Addendum #1

Big Springs Trout Hatchery Residence #2035

Date: 6 December 2023
BSPARK Proj. No.: 20011

4 KITCHEN - EAST
SCALE: 1/2" = 1'-0"

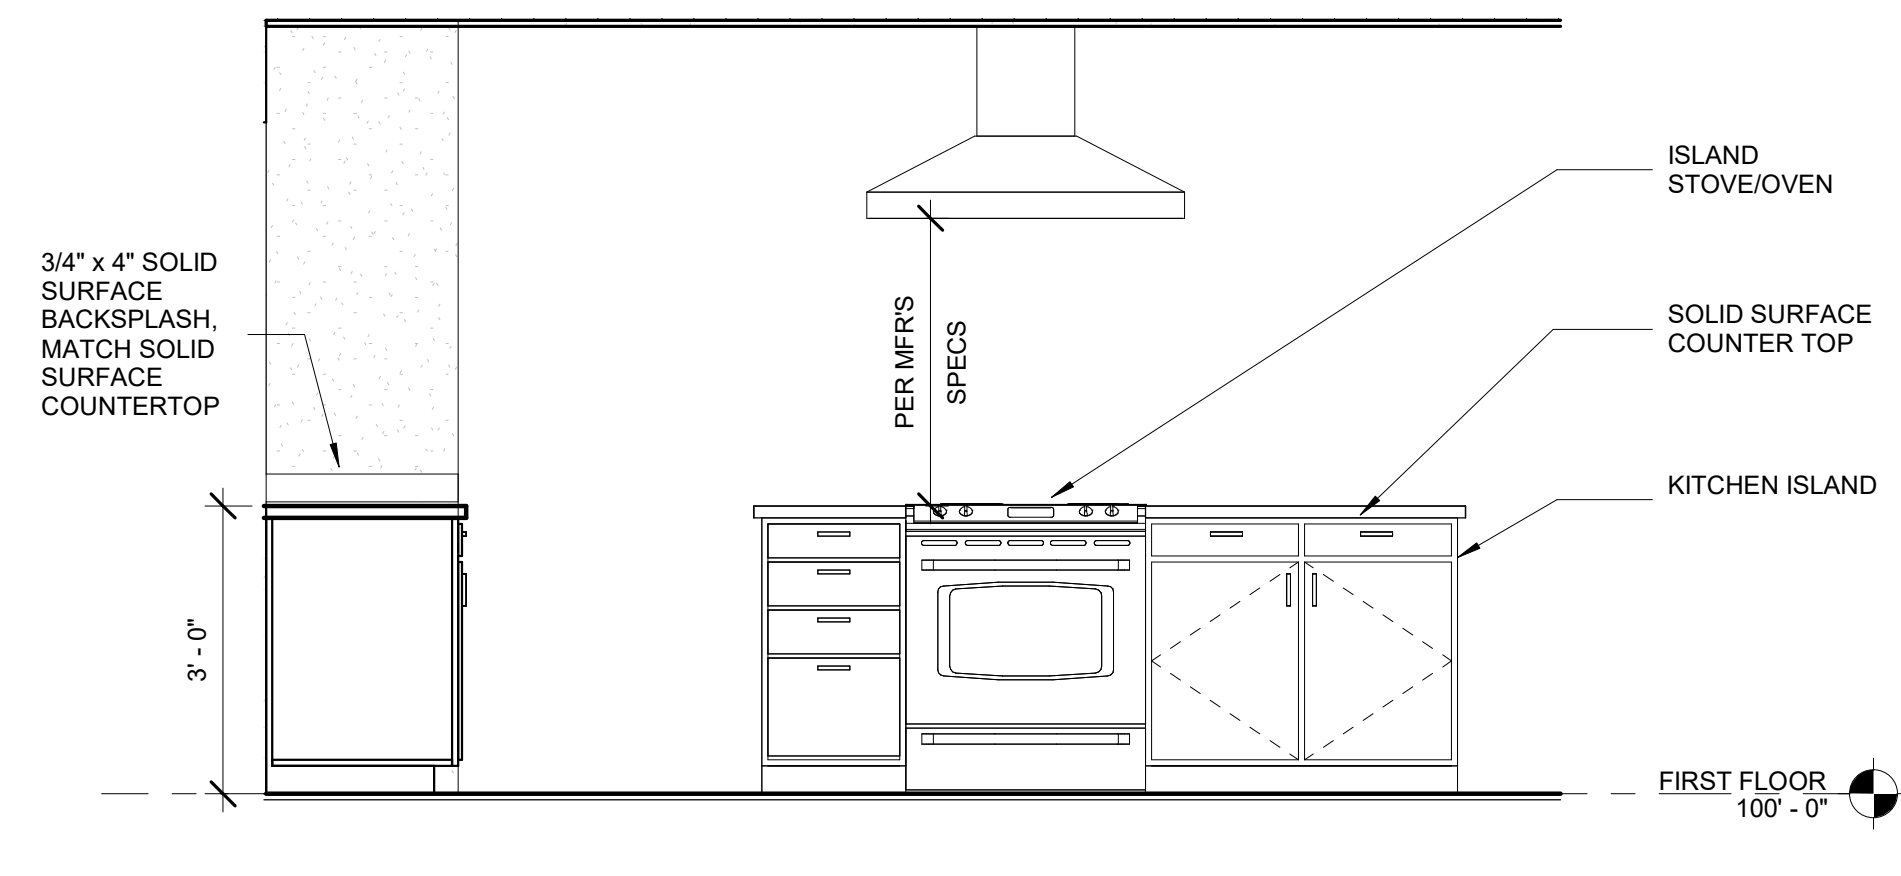
1. Light fixtures Basis-of-design added.
2. Plumbing fixture Basis-of-design added.

SYMBOL	FIXTURE	MANUFACTURER	FINISH	MODEL #	LOCATION	COST	QUANTITY	LINK
WC-1	Bradenton 1.28 GPF One-Piece Skirted Elongated Toilet - ADA Compliant	SIGNATURE HARDWARE	WHITE	447349	BATHROOMS	509	2	https://www.build.com/signature-hardware-948414-12-1/s1712993?uid=4046013&searchId=I7d67N7V4W
LAV-1	Double Basin Kitchen Sink	AMERICAN STANDARD	STAINLESS STEEL	18DB.9321800T.075	KITCHEN, LAUNDRY	282	2	https://www.build.com/american-standard-18db-9321800/s1299037?uid=3091601&searchId=nQRO4bxGNB
	Single Hole Pull Down Faucet	KOHLER	MATTE BLACK	K-596-VS	KITCHEN, LAUNDRY	283	2	https://www.build.com/kohler-k-596/s563679?uid=1770065&searchId=MvGBAseUIC
LAV-2	Studio Drop-in Bathroom Sink	AMERICAN STANDARD	WHITE	643001.02	BATHROOMS	220	2	https://www.build.com/american-standard-0643-001/s1068446?uid=2575949&searchId=5PKpUzUzC

1.2 GPM Single Hole Bathroom Faucet	AMERICAN STANDARD	MATTE BLACK	7353101.243	BATHROOMS	245	2	https://www.build.com/american-standard-7353-101/s1236102?uid=4538759&searchId=bYVGMvAJoy
SH-1	New Solar Collection Bathtub 30x60"	AMERICAN STANDARD	WHITE	263112.02	BATHROOMS	446	1	https://www.build.com/american-standard-0263-112/s821115?uid=2114385&searchId=2C6THZ11W
	Studio S Shower System, 24" Height	AMERICAN STANDARD	POLISHED CHROME	S-SV-3.002	BATHROOM	471	1	https://www.build.com/american-standard-studio-s-sv-3/s1708391?uid=4033624&searchId=rqBuhR1VpU
SH-2	Acrylic Backwall Shower Kit	DREAMLINE	WHITE	SHBW-1536760-00	BATHROOM	530	1	https://www.build.com/dreamline-shbw-1536760-00/s1832604?uid=4345973&searchId=uxPnT04AKB
	Frameless Pivot Shower Door	DREAMLINE	SATIN BLACK	SDAD345720VXX09	BATHROOM	630	1	https://www.build.com/dreamline-sdad345720vxx/s1824873?uid=4330858&searchId=5JToId6HX
	Studio S Shower System, 24" Height	AMERICAN STANDARD	POLISHED CHROME	S-SV-3.002	BATHROOM	471	1	https://www.build.com/american-standard-studio-s-sv-3/s1708391?uid=4033624&searchId=rqBuhR1VpU
